W6MC In-line Breaker and C7BM In-line Motorized Disconnect Switch

Notification of Approval of Connection Proposal

CAA ID Number: 2003-EX148

Assessment Report

Figure 1

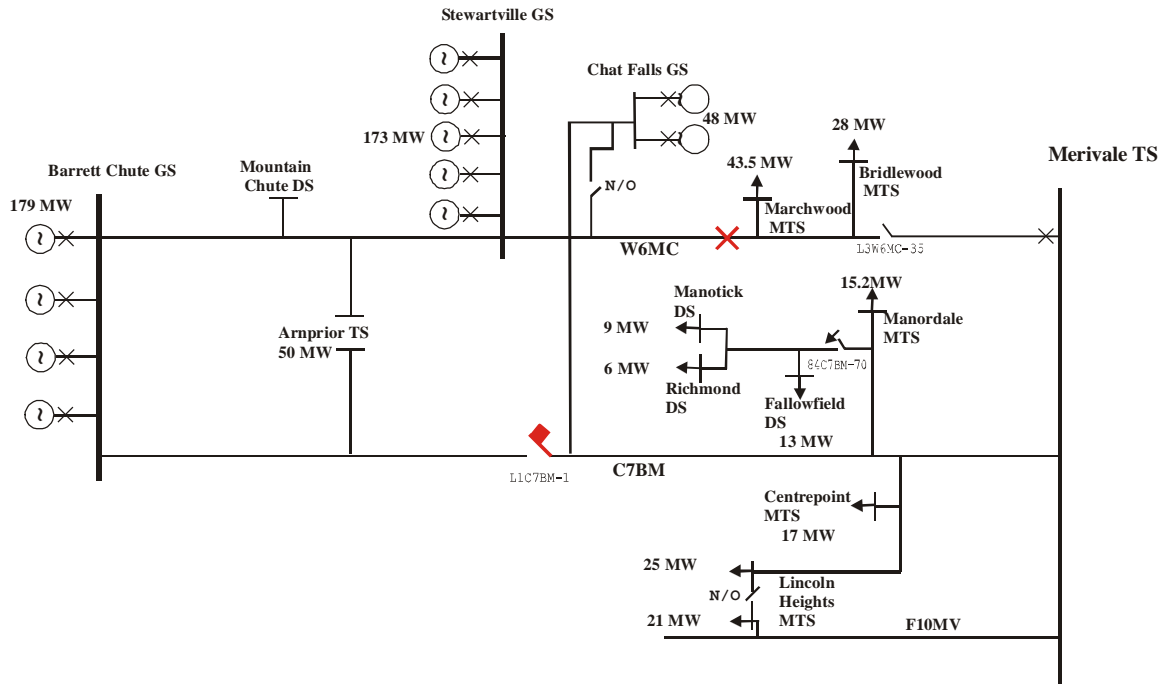
The locations of the new equipment are shown in Figure 1. At this time, the operating designations of the new in-line breaker on circuit W6MC and the two line sections on either side of the new breaker are unknown.

The specifications of the new 115 kV breaker would be adequate for the current system. However, it does not comply with the Transmission System Code requirement of having maximum fault interrupting capability of 50 kA for 115 kV breakers. Should a third party initiate a development that

increases the fault level in this area beyond the capability of the replacement breaker, then HONI would be expected to bear the cost of having to replace the breaker again.

The current functionality of the Stewartville generation rejection (G/R) scheme must be retained. In particular, the scheme includes G/R for faults on circuit W6MC. The installation of a new in-line breaker on W6MC will require both line sections on either side of the breaker to participate in the G/R scheme. The Stewartville G/R scheme must be revised and modified accordingly.

- HONI design all new or modified protection systems in accordance with the applicable standards and submit complete information on all new or modified protection system settings to the IMO as soon as it becomes available. It should be noted that the protection systems data, including autoreclosure settings, is required for the facility registration process.
- HONI replace the in-line breaker installed on circuit W6MC to comply with the Transmission System Code if additional developments in the area result in fault levels exceeding 40 kA.
- HONI retain the current functionality of the Stewartville generation rejection scheme for faults involving circuit W6MC.
